Ref. No.	Issuer company	Issue (yyyy/mm/dd)	Last modification (yyyy/mm/dd)
PV15DSC513	Digital Imaging Group	2015/09/18	2016/11/15
Subject			
<b>Compatibility between LCD MODULE and MAIN BOARD ASSY</b>			
Model (System model)	Destination	Serial number	Color
DSC-H300	All	All  ~	All
DSC-H400	All	All  ~	All

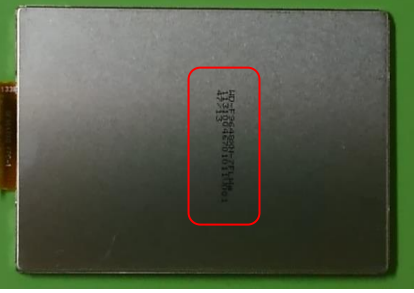
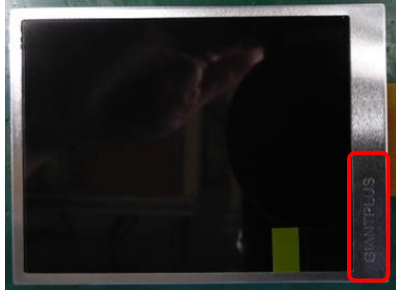
The compatibility needs to be considered for the combination of LCD MODULE and MAIN BOARD ASSY. If either of these parts has to be replaced, confirm the following [Combination Table].

The withdrawal of the original LCD maker from LCD business:

Since any LCD having met the same specification was not found as an alternative, the compatibility needs to be considered for the new LCD.

When replacing LCD MODULE or MAIN BOARD ASSY, see each matrix below for DSC-H300 or DSC-H400, and choose a suitable pair of parts.

**Method to distinguish LCD MODULE**

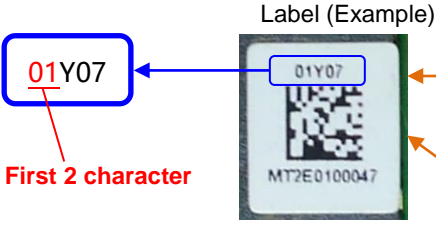
Front bezel: Engraved string	Back bezel: Location of printed string	Part No. for DSC-H300	Part No. for DSC-H400
Old	None 	1 location (Center of Bezel) 	A-1989-699-A	4-537-603-01
	With Engraved string 	1 location 	A-2076-066-A	A-2076-067-A
New	With Engraved string 	2 locations 	1-812-310-11	1-812-310-21

Note: Shape of FPC
